**RFP 2025-02  
REQUEST FOR PROPOSALS  
FOR THE  
RENOVATION OF ROCKLAND GREEN ADMINISTRATIVE HEADQUARTERS  
AND  
CONSTRUCTION OF AN IMMERSIVE THEATRE EXPERIENCE  
AT  
172 MAIN STREET IN NANUET, NY 10954**

**To:** All Potential Proposers  
**From:** Rockland Green  
**Subject:** Addendum Number 3  
**Project:** Rockland Green Renovation & New Immersive Theatre Experience at 172 Main Street, Nanuet, NY 10954  
**RFP No.:** RFP 2025-02  
**Date:** April 10, 2025

This Addendum Number 3 is issued to modify the Request for Proposals No. 2025-02 (the “RFP”) for the above referenced project. All potential Proposers are hereby notified of the following change:

Drawing No.  
**P002**

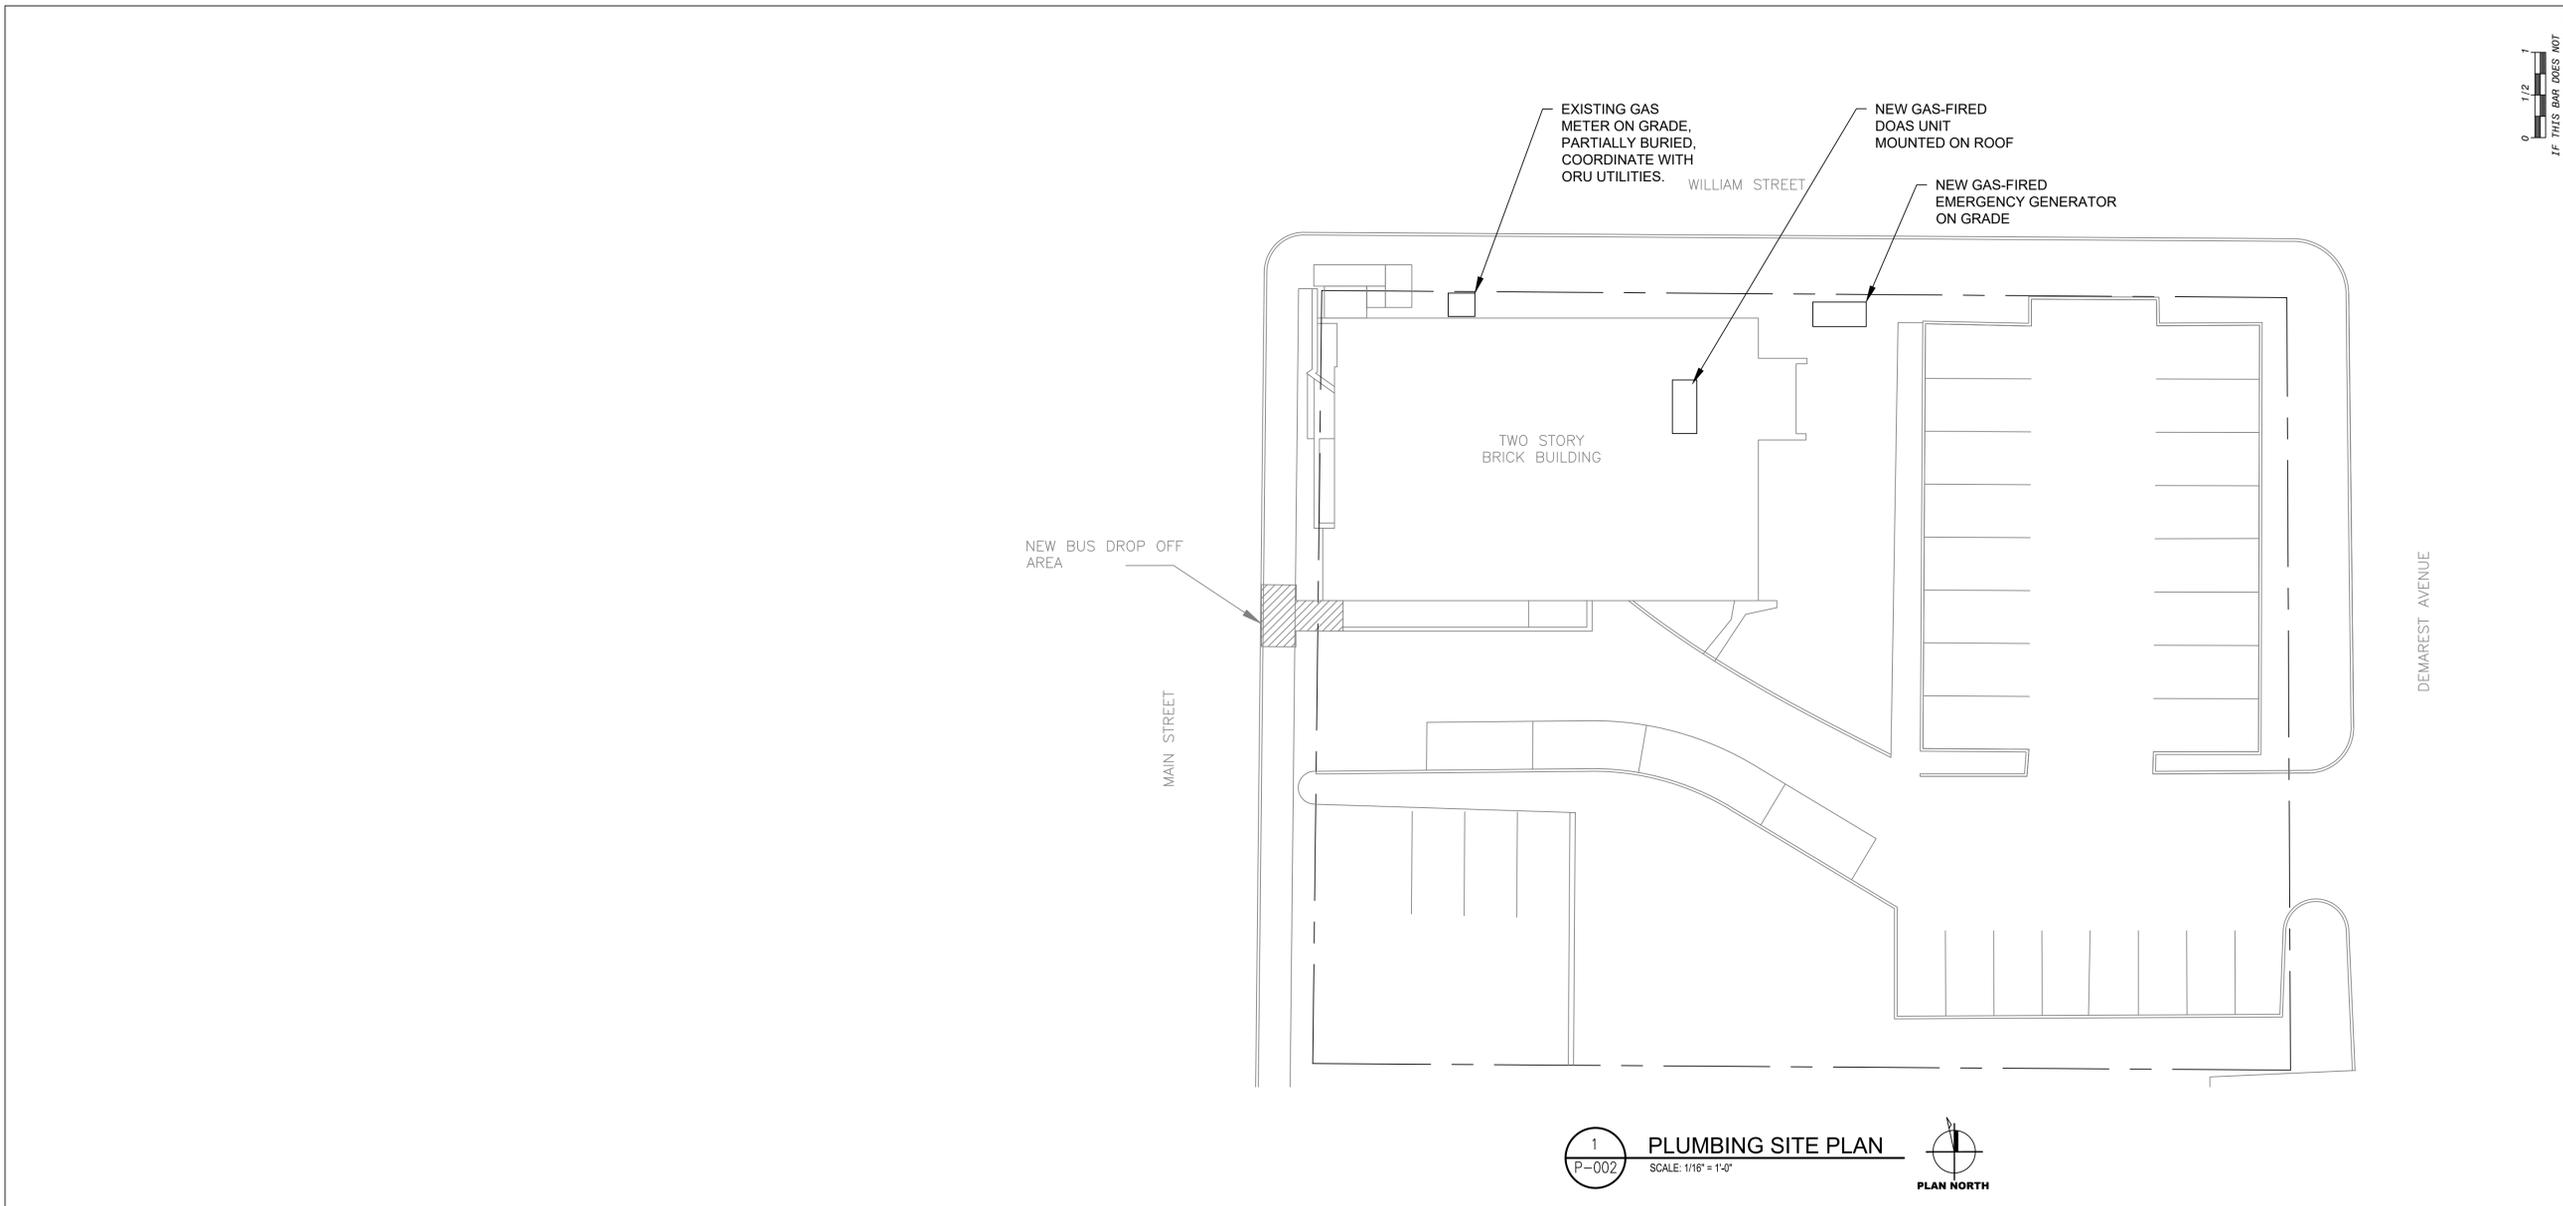
- P002 Revised Gas Load Schedule, Usage (CFH) for DOAS and Total updated.
- M002 Revised Ventilation Schedule to show correct airflow ratings as per code, rearranged schedule so rooms are labelled in order. Revised Dedicated Outdoor Air System Schedule to ensure adequate outside air ventilation is provided.

Drawing No.  
**M003**

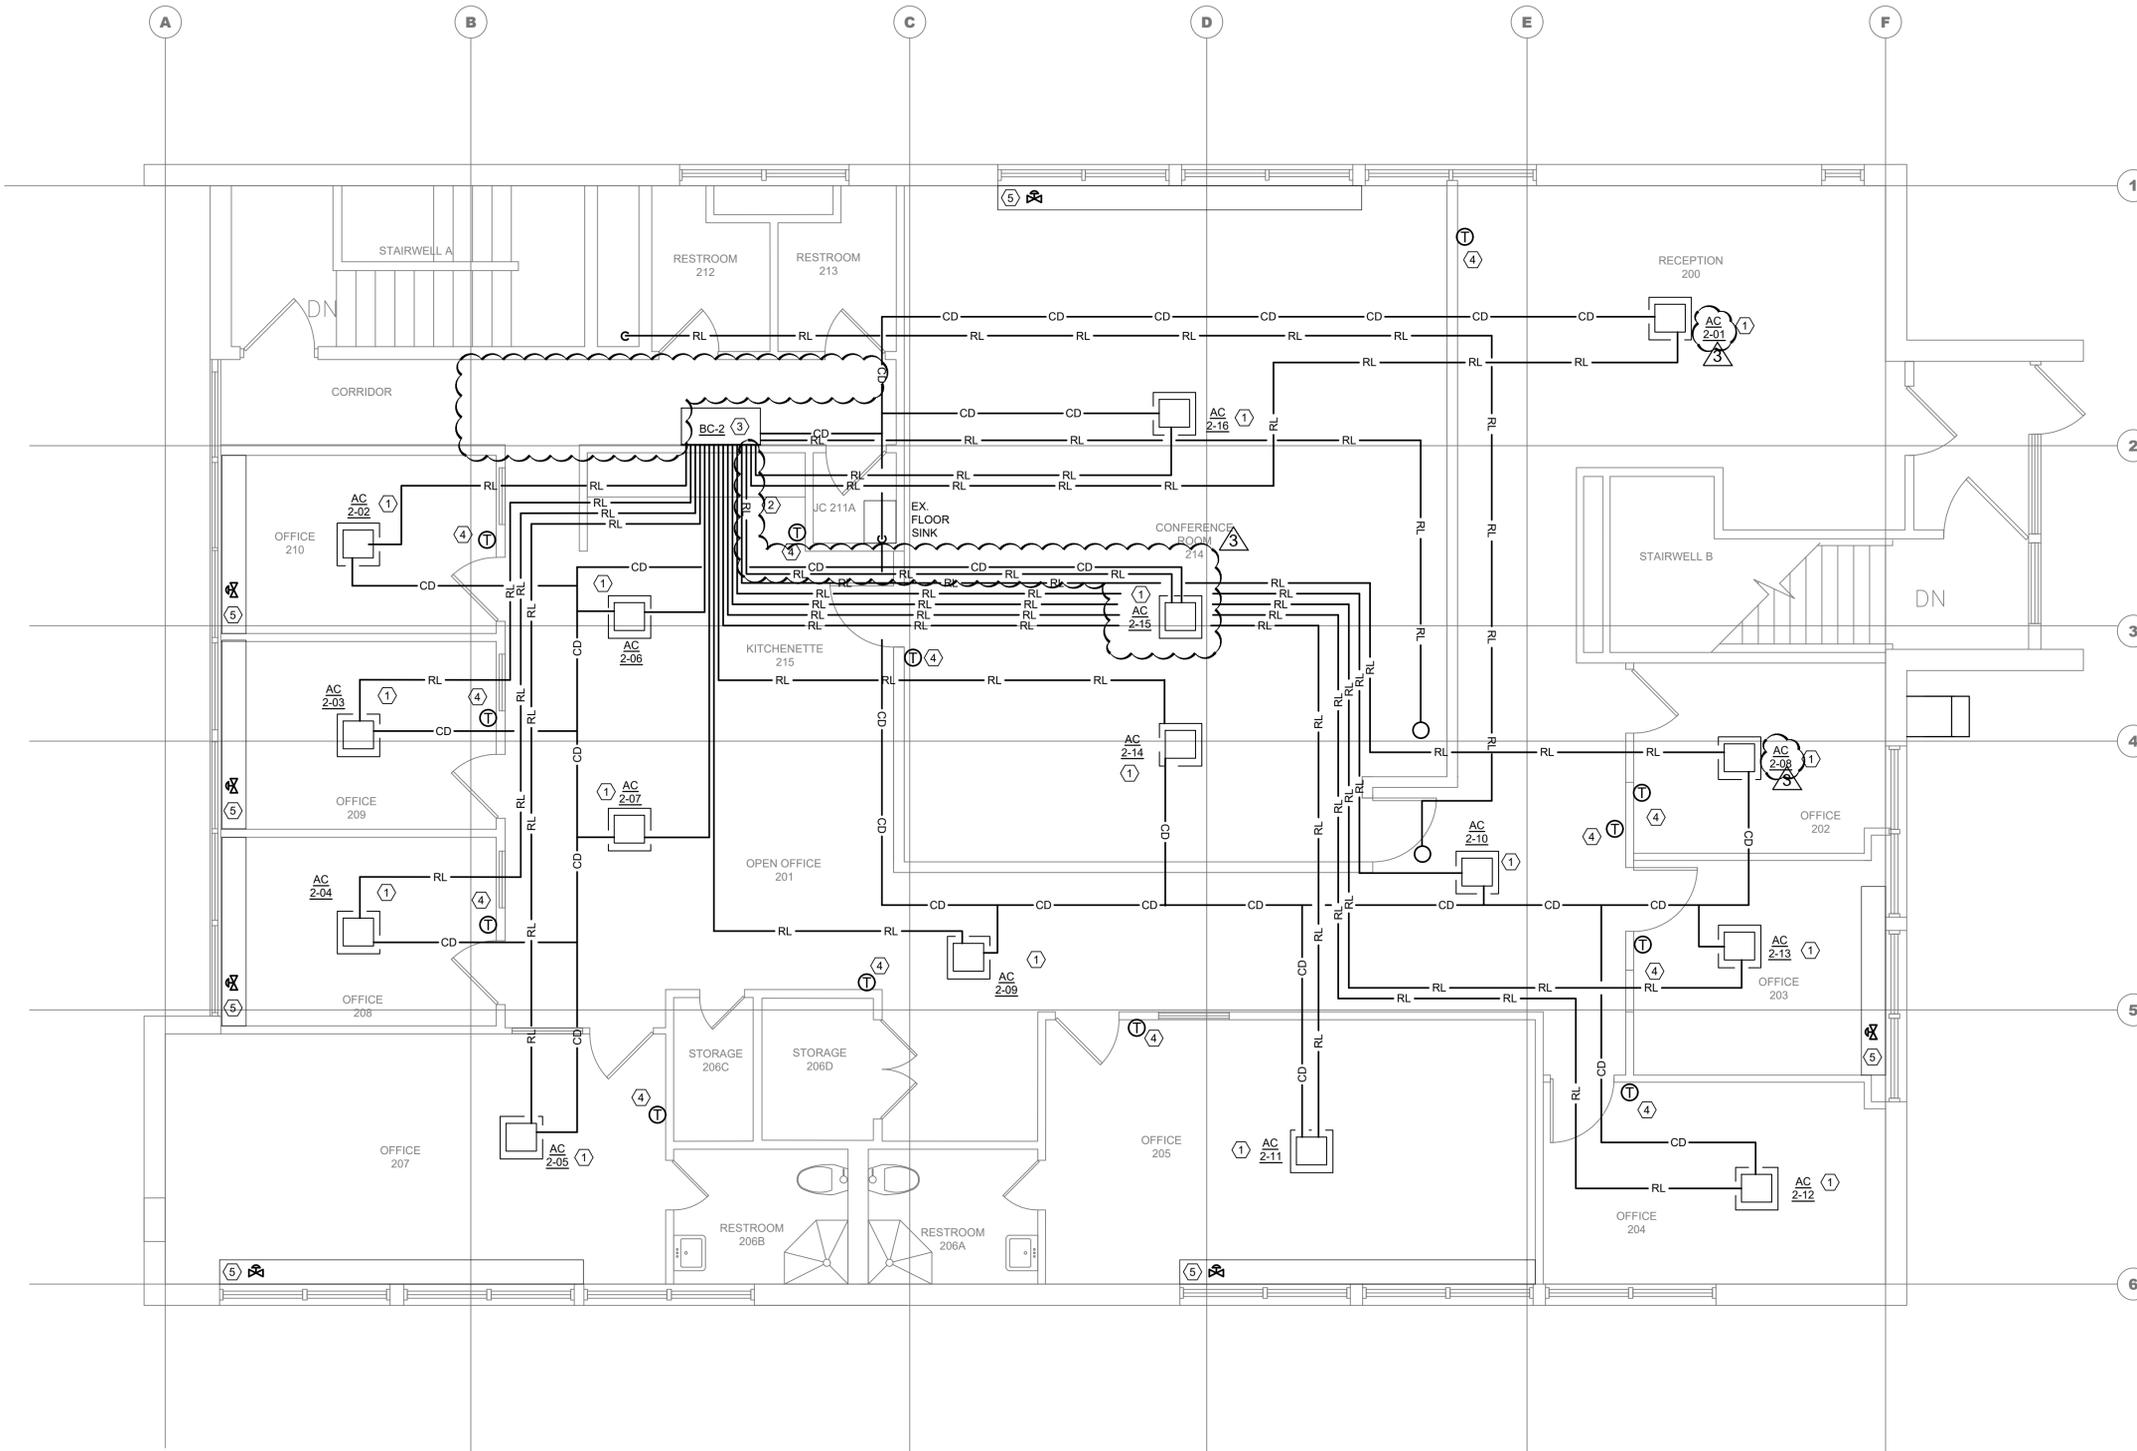
- M003 Revised Indoor VRF unit schedule, Outdoor VRF Unit Schedule and VRF Heat Recovery Branch Circuit Controller to ensure adequate cooling for the Conference Room.

© COPYRIGHT, MICHAEL SHILALE ARCHITECTS, ALL RIGHTS RESERVED.  
Drawing Title  
**MECHANICAL SECOND FLOOR PIPING INSTALLATION**  
Drawing No.  
**M102**

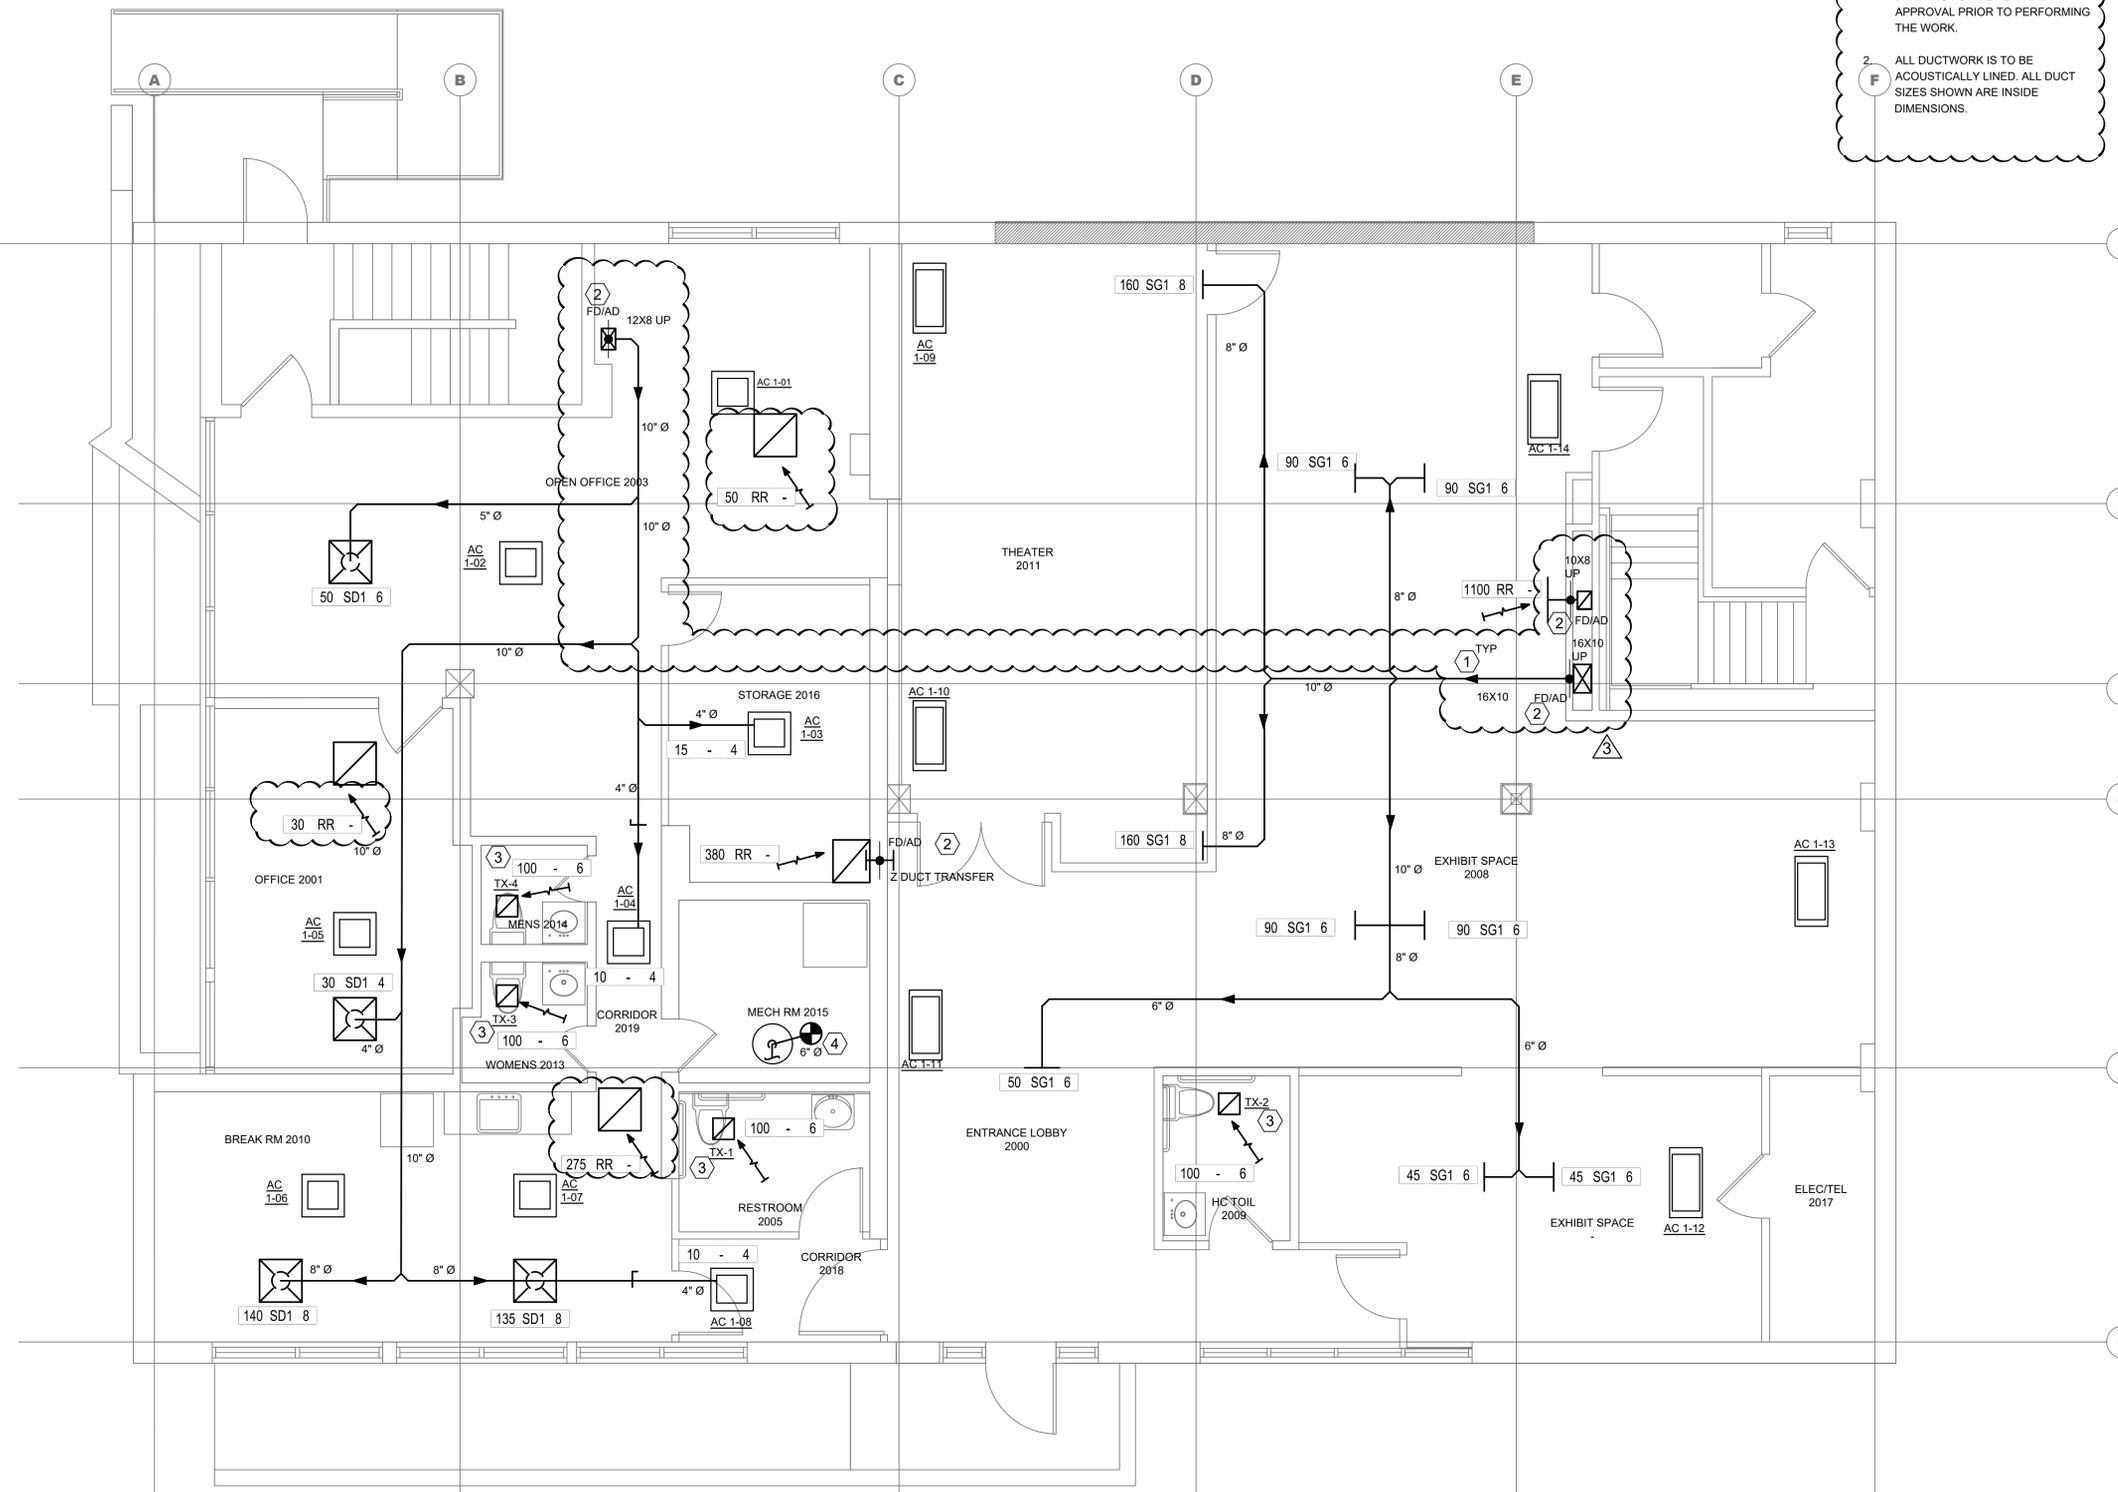
- M102 Revised Second Floor Plan Piping Layout to ensure adequate cooling is provided for the Conference Room.
- M201 Revised duct layout on First Floor, added return registers in various locations, added fire dampers at fire rated partitions and added General Notes to clarify the work.
